## **REMARKS**

### ***Status of the Claims***

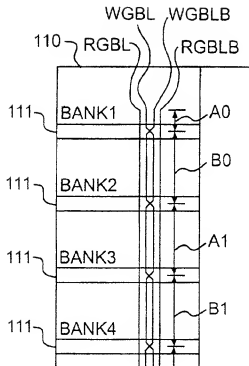
As shown below, Shimazaki's Figure 13 shows four bit lines disposed inside the core of a memory integrated circuit: RGBL, WGBL, WGBLB and RGBLB, with the WGBL and WGBLB bit lines periodically twisted at the segment boundaries for segments B0, A1, B1, etc. Paths RGBL and RGBLB are shown as remaining apart a consistent distance, and not becoming nearest neighbors along any of the segments (A0, B0, A1, and B1).

Clearly, Shimazaki et al. calls for reordering proximity of only 2 wires. Each line, as a result, does not have each of the other lines as a nearest neighbor for at least one of the portions of the path, as required by the claims.
